For Immediate Release: June 16, 2020

## New Parts for the RC10B74

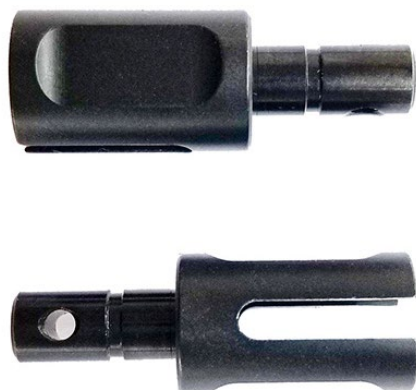
**#92262 Differential Outdrives** are an updated version of the original #92136 RC10B74 front or rear outdrives. They feature less machining work to provide a more durable and economical outdrive. Their length is 1mm shorter than the original outdrives to reduce chipping around the edges.

**#92272 RC10B74 Steering Block Arms** are a new and stronger design for the RC10B74 buggy. Keeping the original steering geometry, the 2.5mm carbon fiber parts have a larger cross section and radii that greatly improves durability. The steering stop area has been modified to allow for the popular racer modification of grinding the plastic steering stop for additional throw on tight tracks.
